DINING OUT NYC

COMMUNITY BOARD RECOMMENDATION FORM

Business Name: Ama La Vita

Cafe Address: 121 W 19TH ST, NEW YORK, NY, 10011

SECTION 1: Site Plan

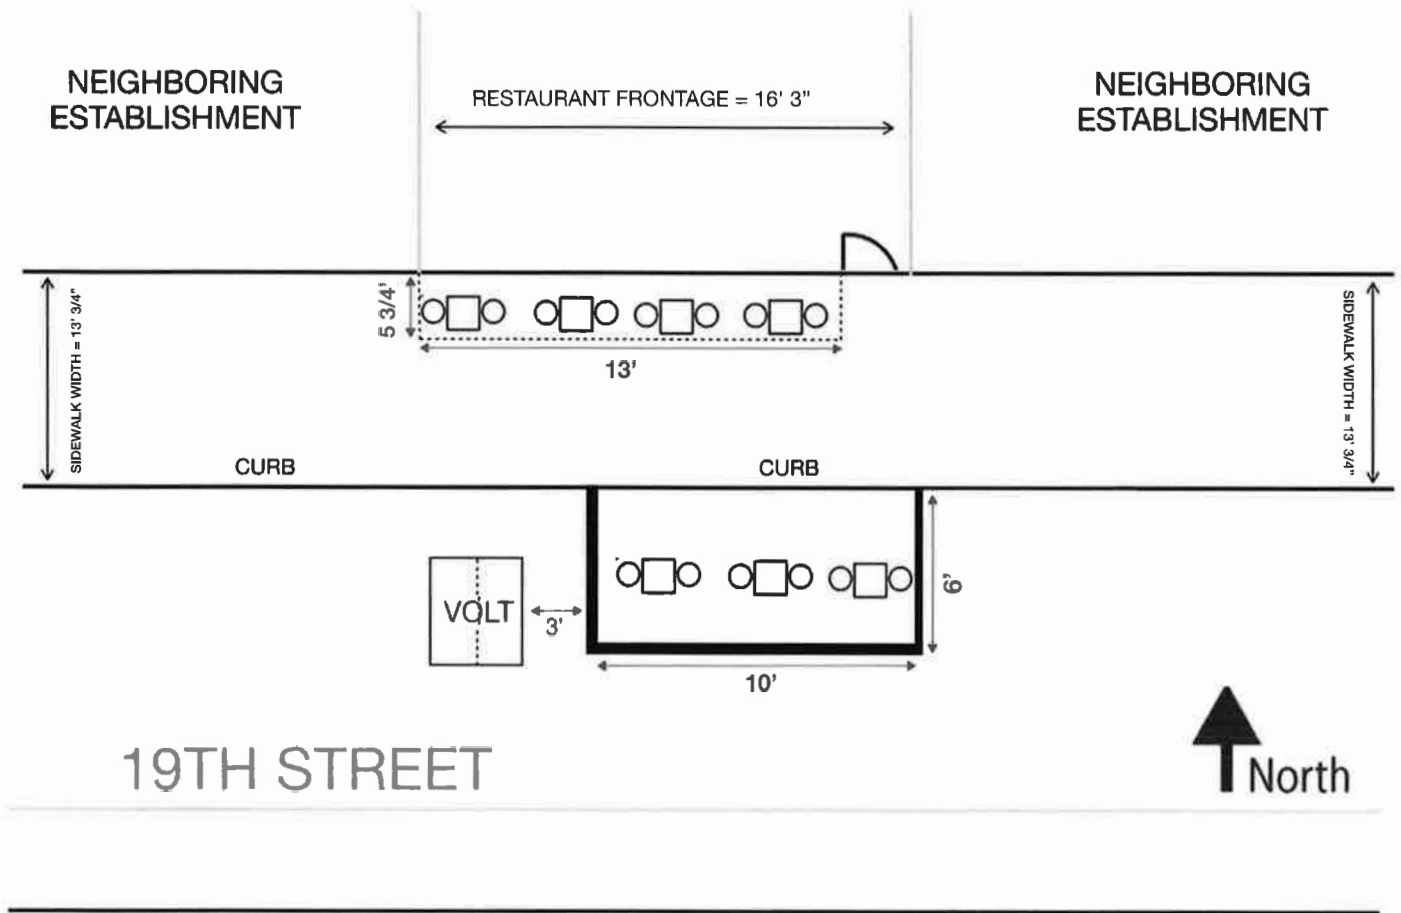
The number of tables and seats on the proposed Site Plan (4 tables with 2 seats each) cannot fit in the permitted footprint of the sidewalk cafe. Applicant has agreed to remove 1 table with 2 seats, reducing the cafe to 3 tables with 2 seats each.

To fit within the permitted footprint of the sidewalk cafe, MCB4 requests modifications to the cafe. Applicant has agreed to these modifications, has removed 1 table with 2 seats, and has prepared the attached Revised Site Plan, reducing the cafe to 3 tables with 2 seats each.
